Technical Advisory

PGx303 PowerG Wireless Magnetic Door/Window Contact Magnet Alignment

Date: May 15, 2019

Product: PGx303 PowerG Wireless Magnetic Door/Window Contact

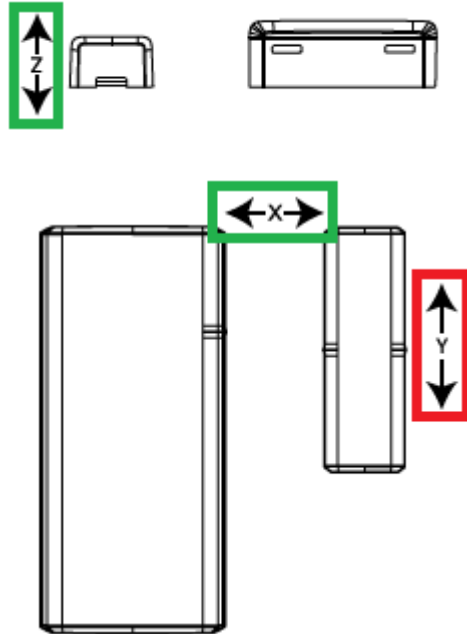
We have discovered a potential issue concerning the use of the PGx303 PowerG Wireless Magnetic Door/Window Contact. If this contact is installed in such a way that the magnet is pulled away from the reed switch along the long edge of the contact, this may result in up to a 20-second delay in communicating the violation to the panel, and if the magnet is restored prior to communication, it may result in the detector missing the violation. The issue is dependent upon how quickly the magnet is removed from the device. If the magnet is removed slowly, such as on a sliding door, it is more possible that the issue can occur.

In the interim, please ensure that the PGx303 PowerG Wireless Magnetic Door/Window Contact is installed so that the magnet moves away from the reed switch on either the X or Z axis, shown in the images below.

Any PGx303 PowerG Wireless Magnetic Door/Window Contact installed with the magnet moving away from the reed switch on the 'Y' axis as in the photo above should be re-positioned so that the magnet moves away from the reed switch on the 'X' or 'Z' axis in the photo above.

To minimize the potential occurrence of the issue, the PGx303 PowerG Wireless Magnetic Door/Window Contact must be installed vertically on a door that slides open horizontally, or horizontally on a window that slides open vertically.
